## Sunnyside Cogeneration Associates

RE: Star Point Waste Fuel - Permit # C/007/042  
Permit Amendment – Roads D, F & L

Title: Roads D, F & L

Three roads are proposed to be classified as Primary and used regularly by refuse hauling / loading vehicles

PROFILE ROAD D  
SCALE: HORIZ: 1" = 100' VERT: 1" = 25'

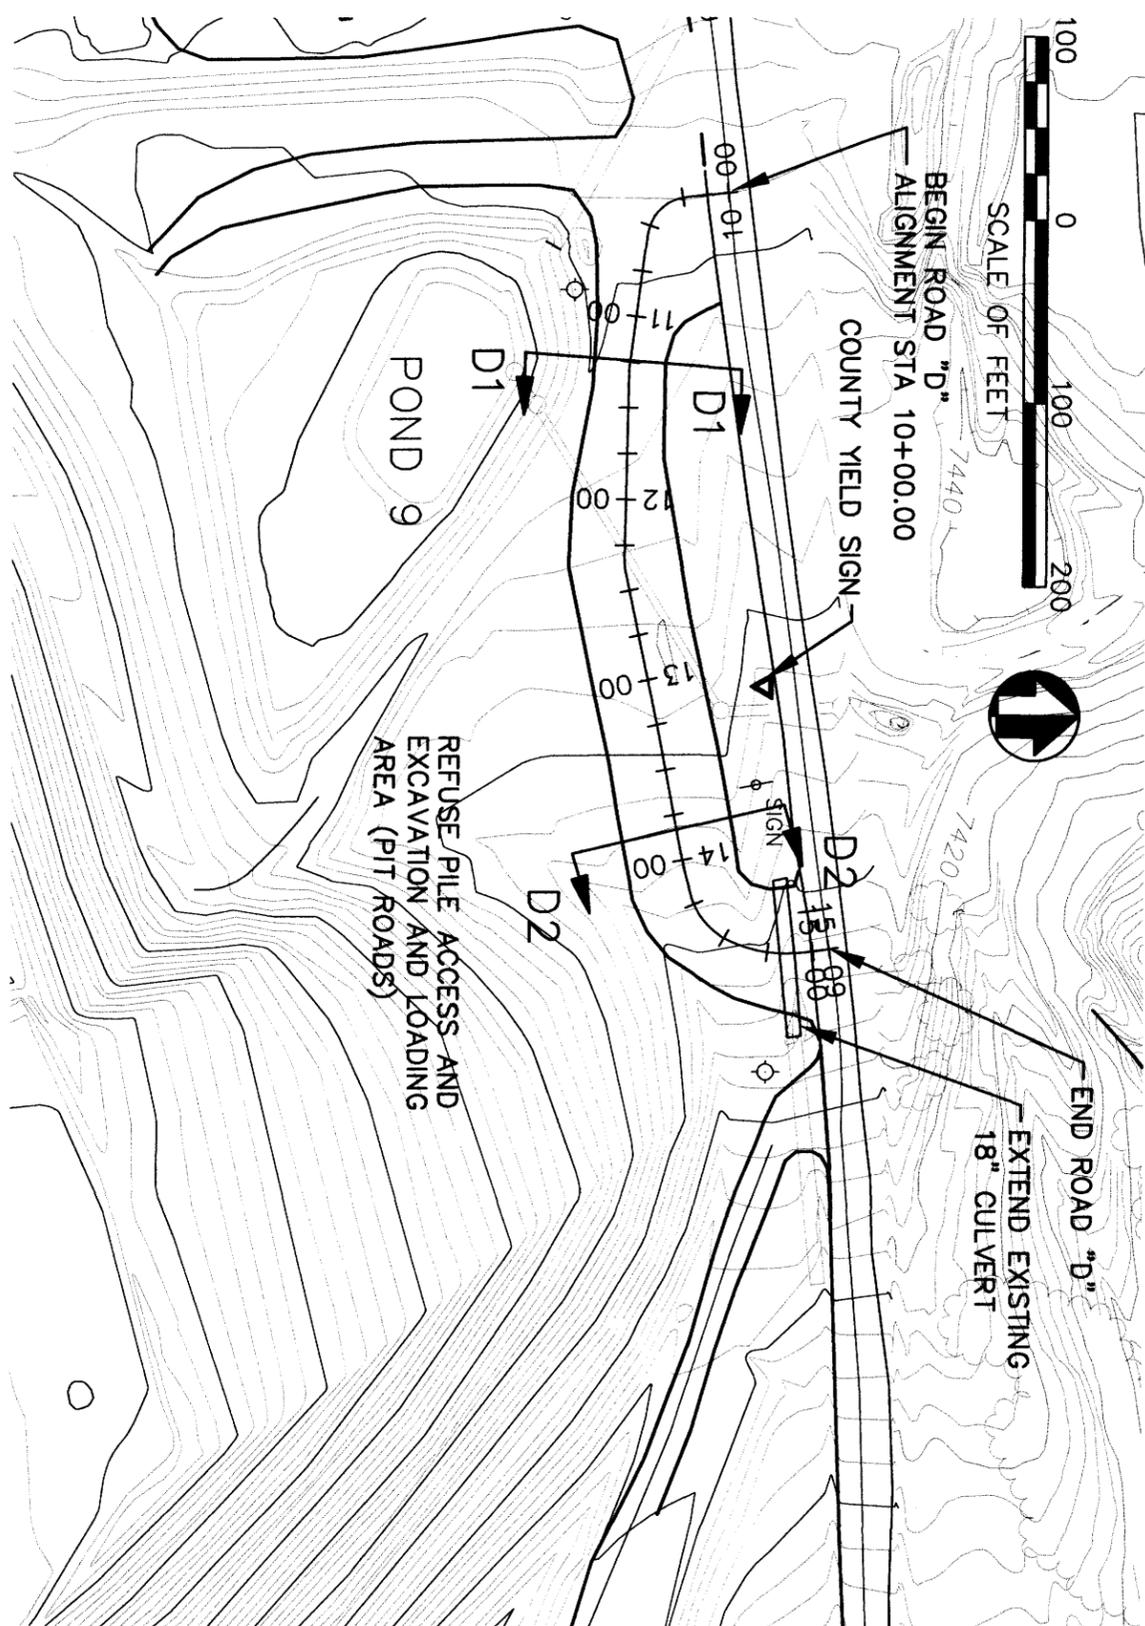
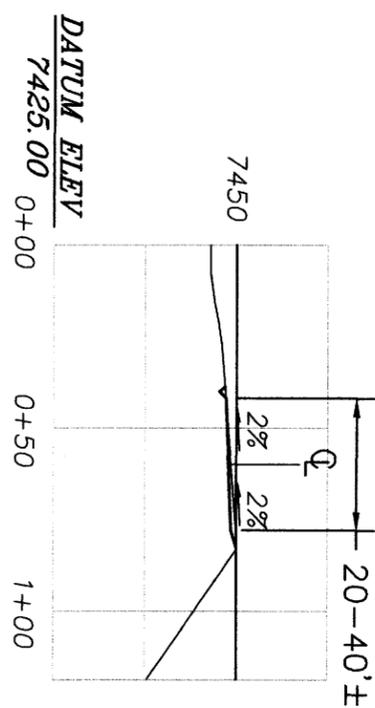
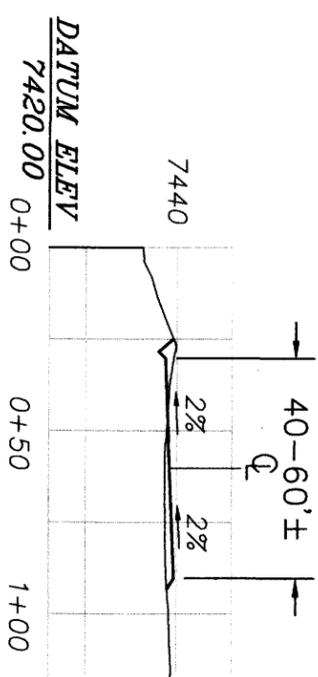
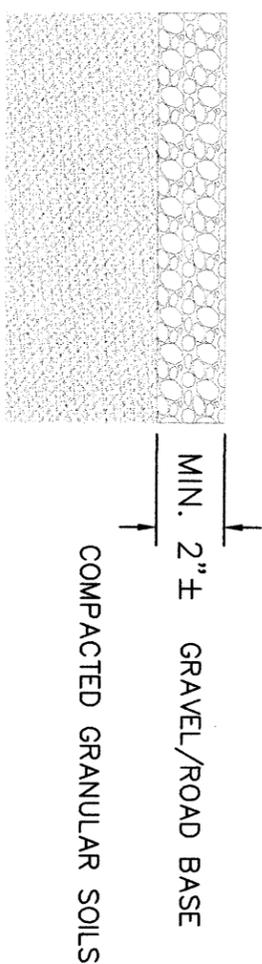
**Primary Road D (Access to Refuse Pile A)** – This access road is intended for regular use by haul trucks to provide access to the northeasterly point of Refuse Pile A. The 20'-60' wide road will have a gravel or road base surface and a grade that ranges from 0% to 10%. This road will also facilitate loading of excavated material from the refuse pile. Construction on this primary road will begin within 1-2 years following DOGM approval.

ROAD F PLAN  
SCALE: HORIZ: 1" = 100'

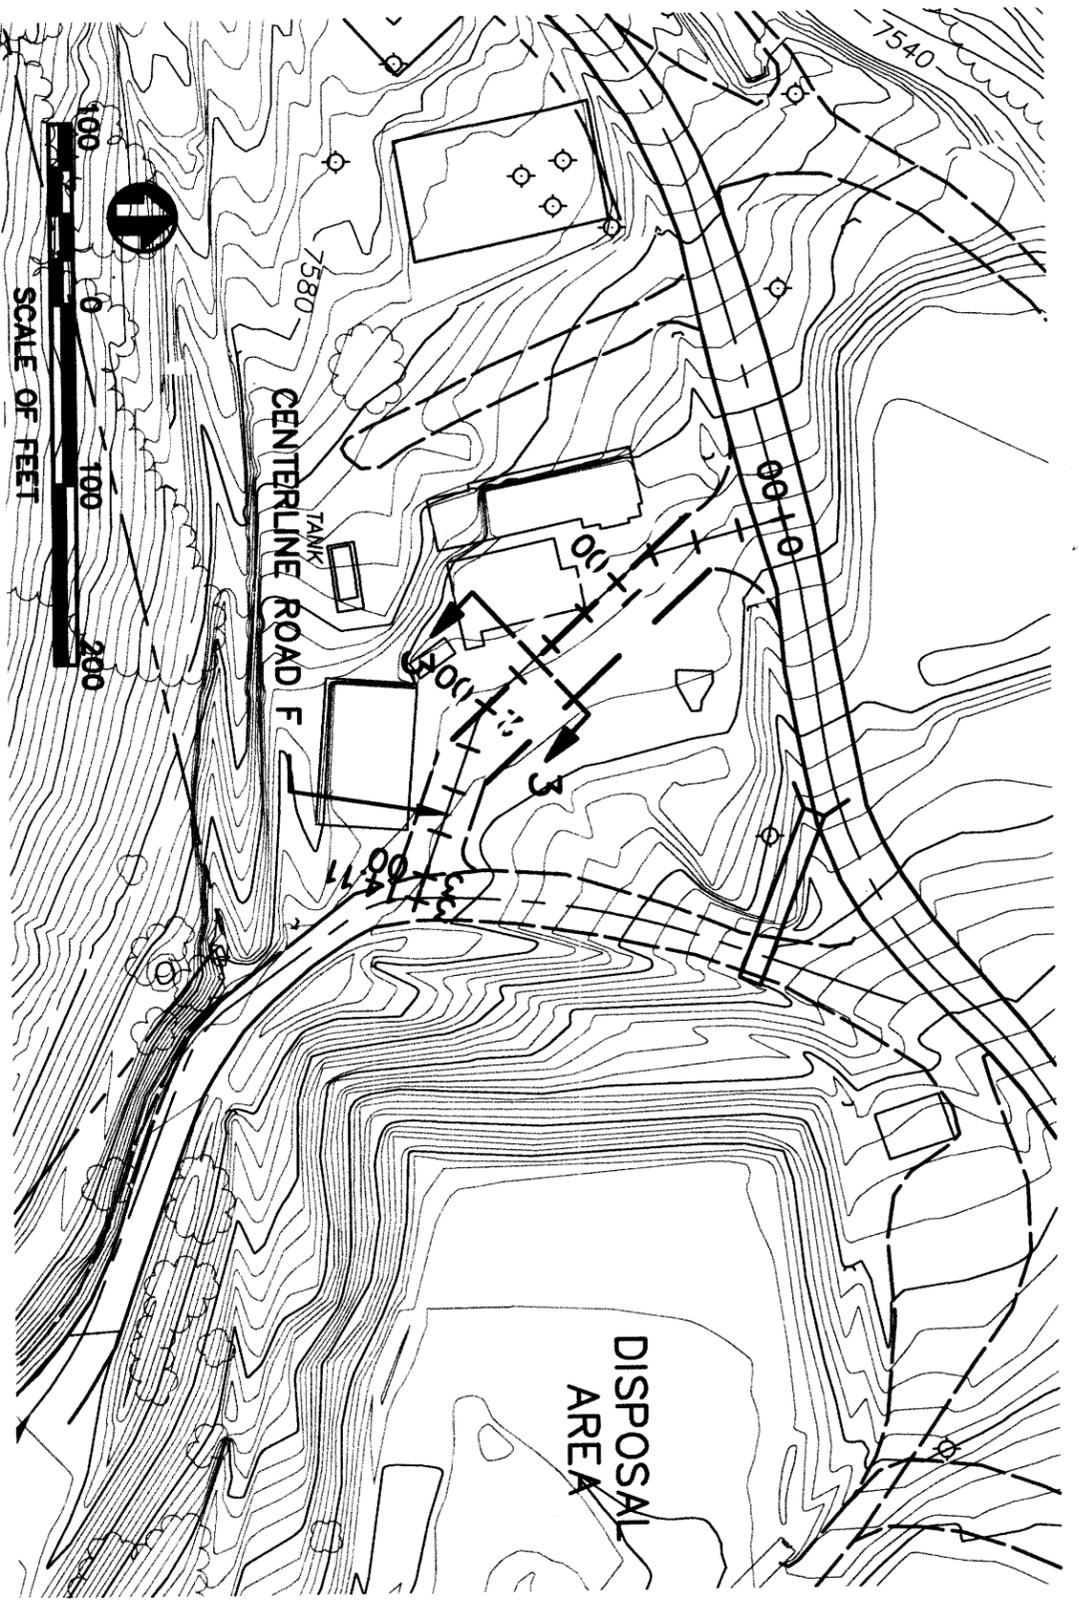
**Primary Road F (Access to Refuse Pile A)** – This access road is intended to provide an access road to the refuse pile at a more gentle grade than the Primary Haul Road and facilitates more efficient travel. The 15-35 ft road will have a maximum grade of 5% and crosses portions of old asphalt parking lot and also has a gravel surface.
